## **SEMMES HIGHLANDS SUBDIVISION, FOURTH UNIT** **RESUBDIVISION OF LOT 23**

The plat illustrates the proposed 5.0± acre, 3 lot subdivision, which is located Southeast corner of Blackstone Road and Firetower Road – within the planning jurisdiction. The applicant states that the site is served by city water and individual septic tanks.

The purpose of this application is to create three legal lots from three metes and bounds parcels.

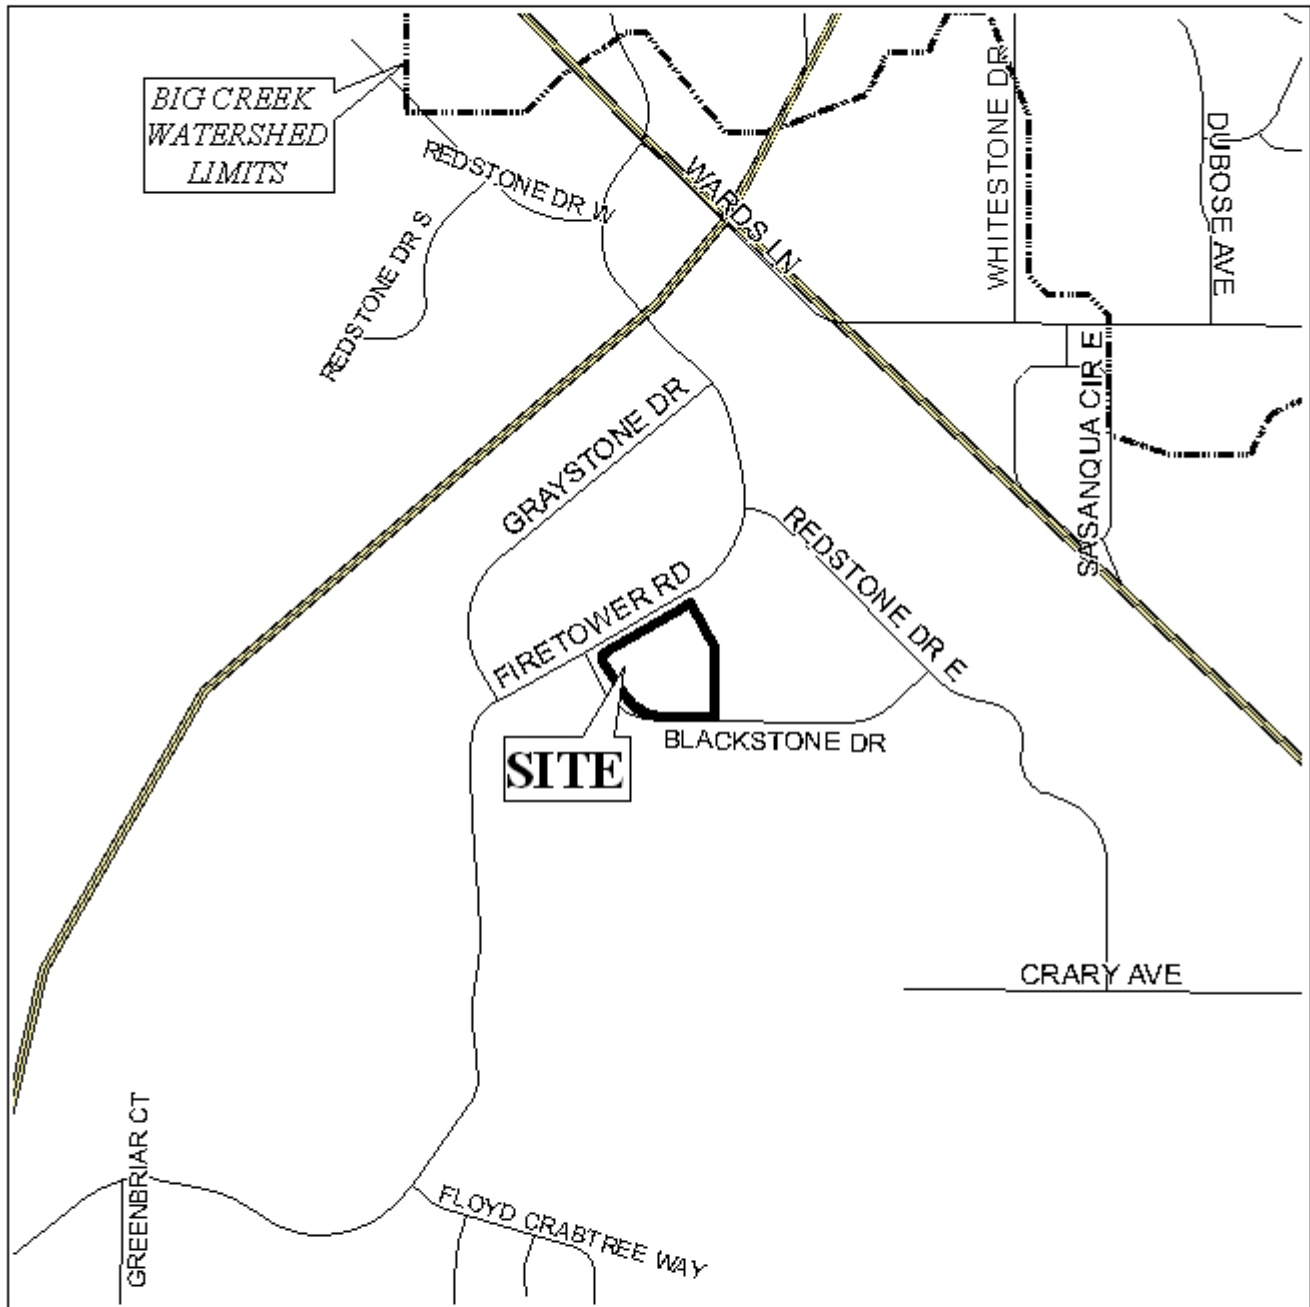
As proposed, Lot 1 has a combined street frontage of approximately 887' along Fire Tower Road and Blackstone Drive. Lot 2 has 171' of frontage along Fire Tower Road, and Lot 3 has 147' along Blackstone Drive. As a means of access management, a note should be placed on the final plat stating that Lot 1 is limited to a maximum of three curb cuts, and Lots 2 and 3 are each limited to one curb cut to Fire Tower Road and Blackstone Drive respectively, with the size, location, and design to be approved by County Engineering and conform to AASHTO standards.

Furthermore, a note should be placed on the final plat stating that any lots developed commercially and adjoin residentially developed property must provide a buffer, in compliance with Section V.A.7. of the Subdivision Regulations.

Based on the preceding, the plat meets the minimum requirements of the Subdivision Regulations and is recommended for Tentative Approval, subject to the following conditions:

- 1) placement of a note on the final plat stating that Lot 1 is limited to a maximum of three curb cuts, and Lots 2 and 3 are each limited to one curb cut to Fire Tower Road and Blackstone Drive respectively, with the size, location, and design to be approved by County Engineering and conform to AASHTO standards;

- 2) provision of a minimum detention capacity volume of a 50 year post development storm, with a maximum release rate equivalent to the 10 year storm pre-development rate, and the placement of a note on the final plat stating that the development has been designed to comply with all other storm water detention and drainage facility requirements of the City of Mobile storm water and flood control ordinances, and requiring submission of certification from a licensed engineer certifying that the design complies with the storm water detention and drainage facility requirements of the City of Mobile storm water and flood control ordinances, as well as the detention and release rate requirements of Mobile County for projects located within the Converse watershed, prior to the obtaining of permits. Certification is to be submitted to the Planning Section of Urban Development and County Engineering;

- 3) placement of a note on the plat / site plan stating that the site must be developed in compliance with all local, state and Federal regulations regarding endangered, threatened or otherwise protected species;

- 4) placement of a note on the final plat stating that any lots developed commercially and adjoin residentially developed property shall provide a buffer in compliance with Section V.A.7. of the Subdivision Regulations; and

- 5) submission of a letter from a licensed engineer certifying compliance with the City of Mobile's storm water and flood control ordinances to the Mobile County Engineering department and the Planning Section of Mobile Urban Development prior to issuance of any permits.
